Note: **DI-2**

DAΦNE EXPERIMENTAL AREA PRELIMINARY STUDY

A. Cattoni, O. Cerafogli, S. Faini

Fig. 1

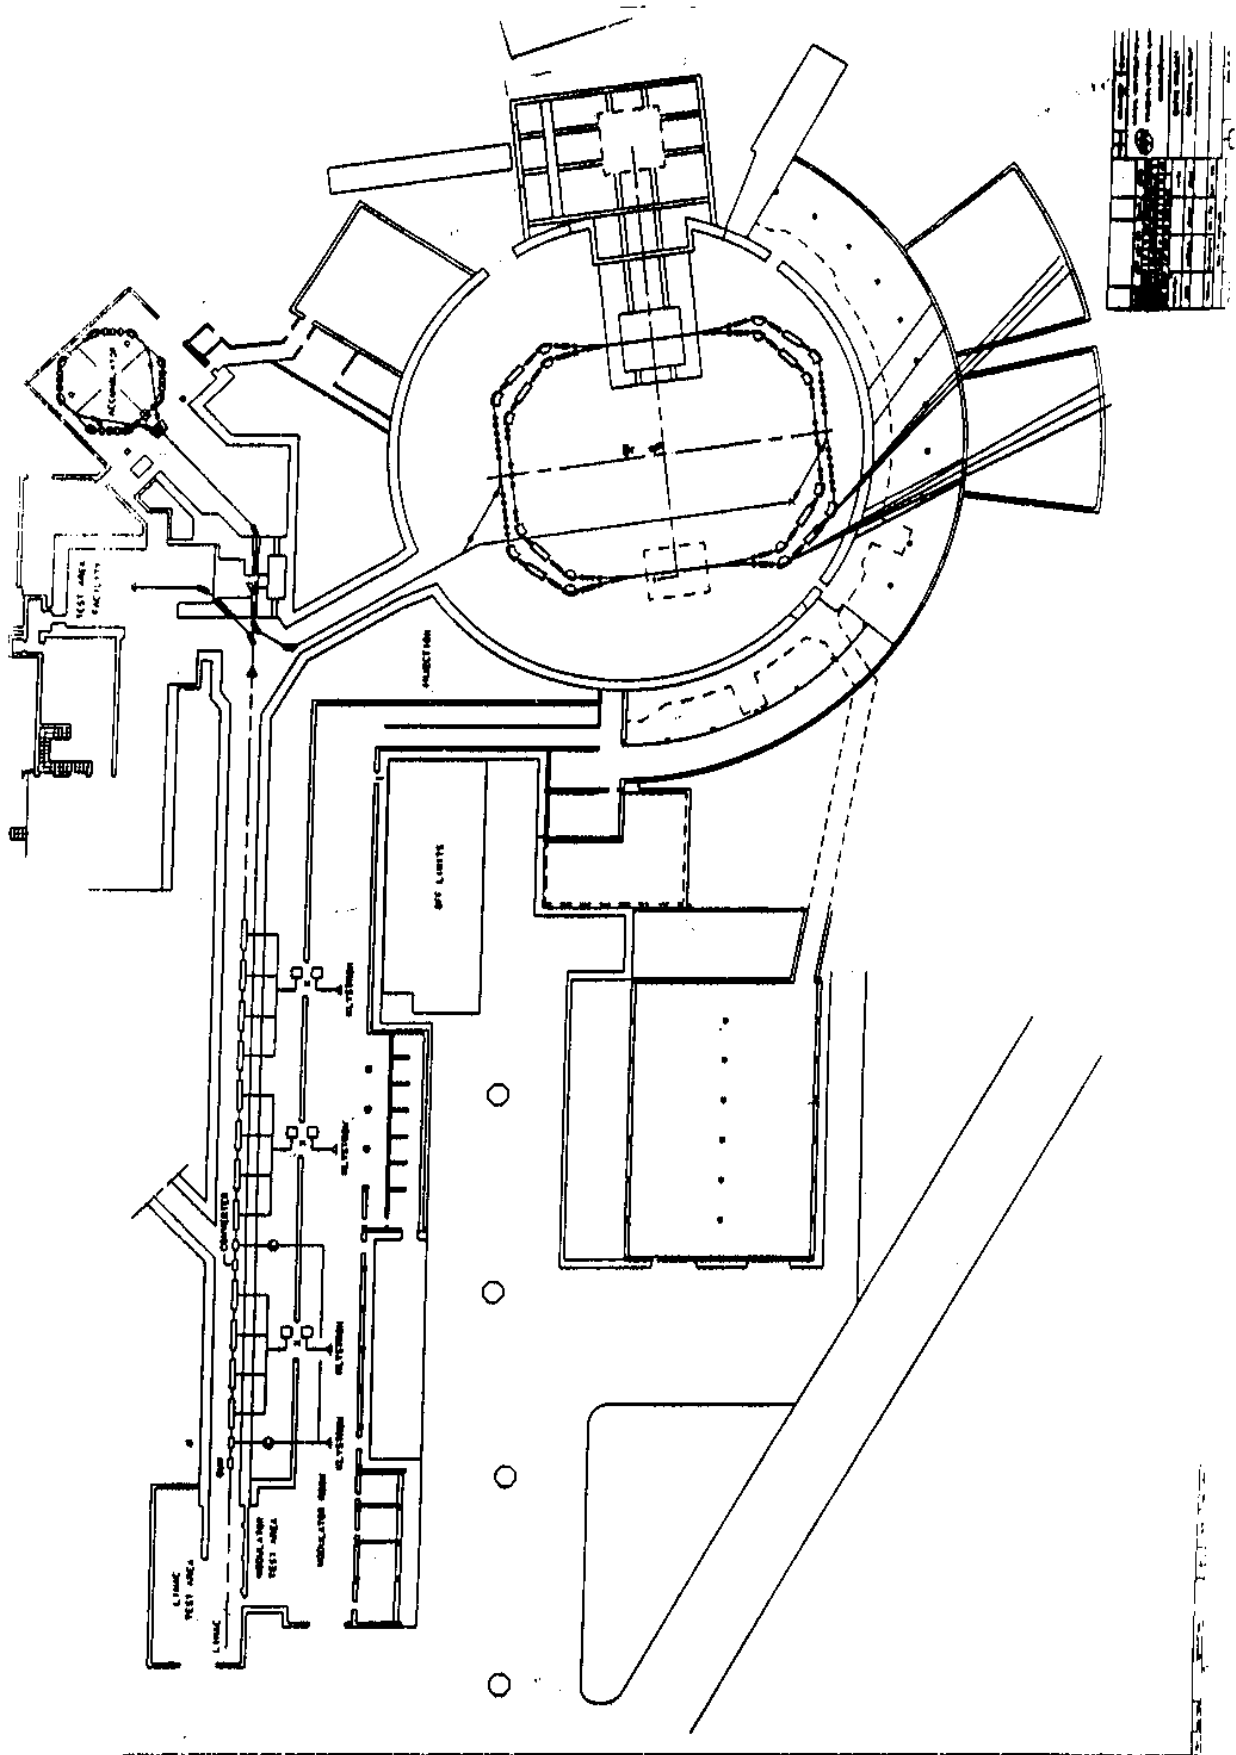
- 3b) To reduce structural problems and many complications in modifying the Adone building wall, would bring to saving time and money.
- C) Bearing this in mind there is a first proposal, sketched in Fig. 1, which shows the plane view of the hall, located where, at present, there is the Puls area.

- The Adone wall structure, facing that area, allows to open an easy aperture to bring the detector on the machine orbit, because the reinforced concrete is missing there, and it is replaced by tufa blocks. The width of this window is much larger than needed, the only limit is the height which must be contained in something less than 4 meters to allow an easy passage. This would bring to unbearable complications if the detector height, over the orbit level, should be kept 3 m and another 2 m vertical clearance, or more, should be foreseen for the cable belt. What is the possibility to lower the DAΦNE orbit plan with respect to the Adone floor has been checked: **1.2 m** above the Adone present floor is the orbit minimal height. One has to do the maximum effort to avoid cutting the Adone building structural part. If the cable belt length, allowing the positioning of the detector on the machine orbit, could develop on one side instead on top of the detector, with the DAΦNE orbit laying at 1.2 m above the Adone present floor, the height of the reinforced concrete to be cut over the tufa blocks would be significantly less than half a meter. But, of course, the goal should be not to cut the reinforced concrete at all and this would limit the detector radial extension, all included, to possibly 2.8 meters. In any case one can expect a saving of time and money up to more than 50% in cutting and restoring the Adone wall (rough evaluation) compared to the first investigated solution (Jet target area).

- The sketched solution, (Fig. 1) shows also the synchrotron radiation fans led into the SCOW and PWA buildings. Photon beam lines from two bendings and from a wiggler magnet are involved.

Fig. 2

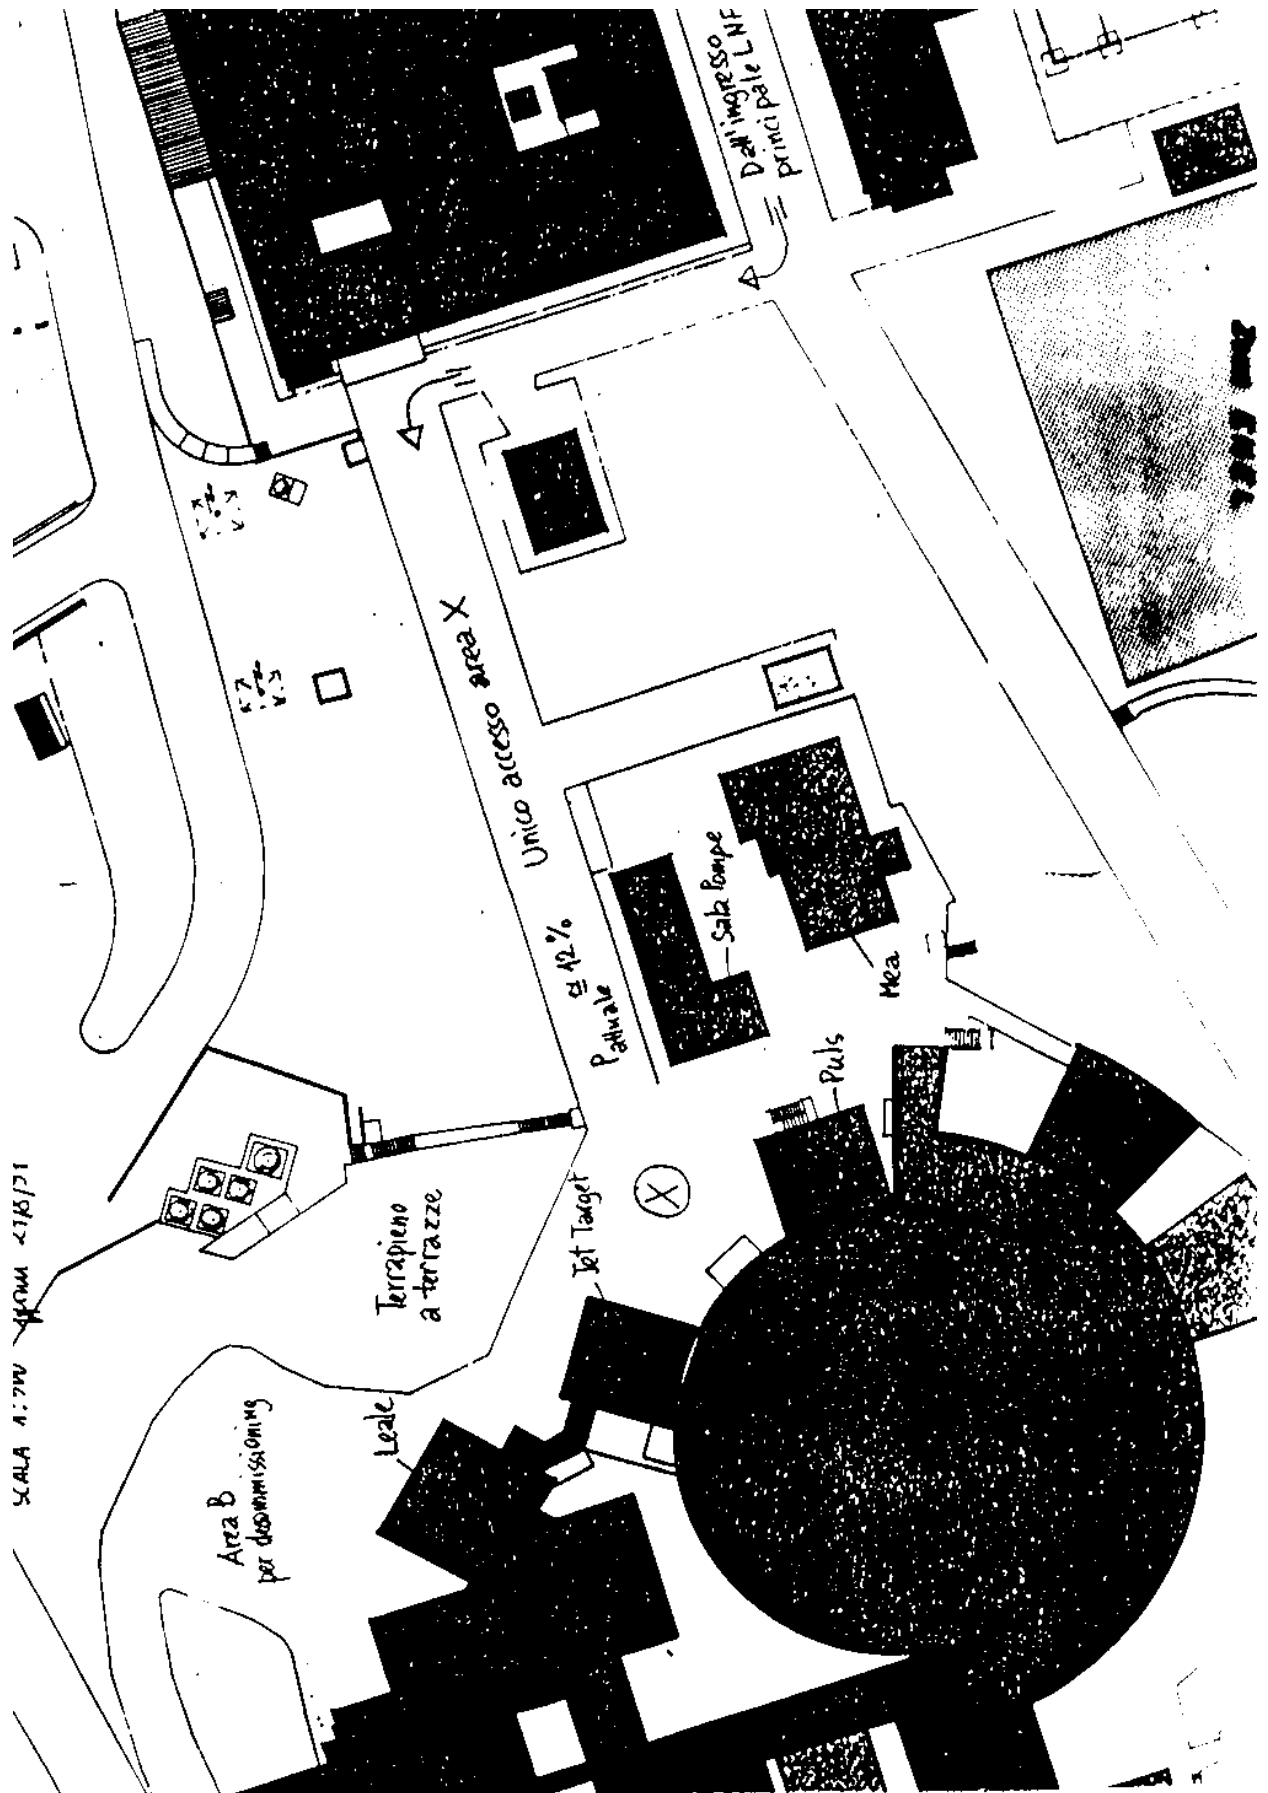
- D) A further investigation concerning the development of the present Adone experimental and servicing area (Fig. 2) has been done from a logistic point of view taking into account the following:

- 1d) Decommissioning of Adone and commissioning of DAΦNE operations (storing areas availability, accessibility, road conditions).

- 2d) Building yards practicability (the possibility to push ahead works in parallel seems to be mandatory: in particular the Puls building demolition and the DAΦNE detector assembly hall construction should not interfere with the Adone decommissioning, the commissioning of the Accumulator Ring for DAΦNE and the new machine component test phase).
- 3d) Availability of a suitable area for the Detector mechanical plants including cryogenics and ambient temperature and humidity control.
